## SERVICE LETTER No. L 148

### MAINTENANCE ALERT

- DATE:** April 30, 2024
- TO:** All operators of ZLIN airplanes
- MODELS AFFECTED:** All Z 242 L aircraft
- SUBJECT:** IN-SERVICE SAFETY EVENT REPORTING
- TIME OF COMPLIANCE:** Immediately after receipt of this letter

Fig. No. 1

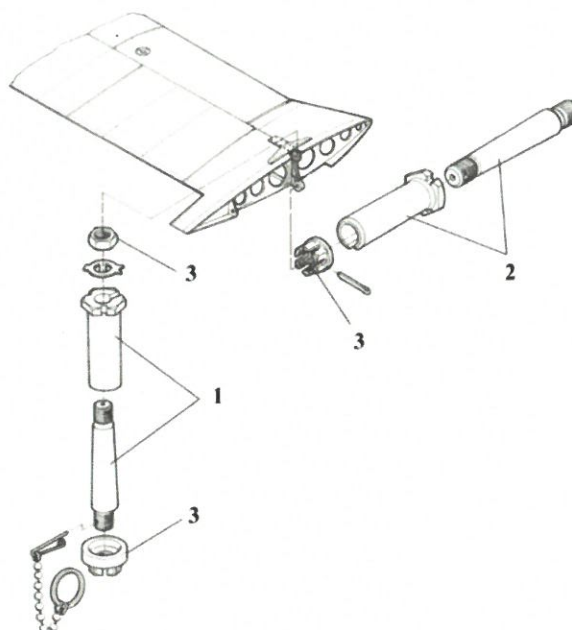
For tightening nuts M10 – see Picture 1, item 3, a torque wrench must be used at all times to meet the requirements of the prescribed tightening torque (23-27 Nm – see Maintenance Manual part 2, chapter 7.5).

**Tightening of nuts without using the torque wrench is forbidden.**
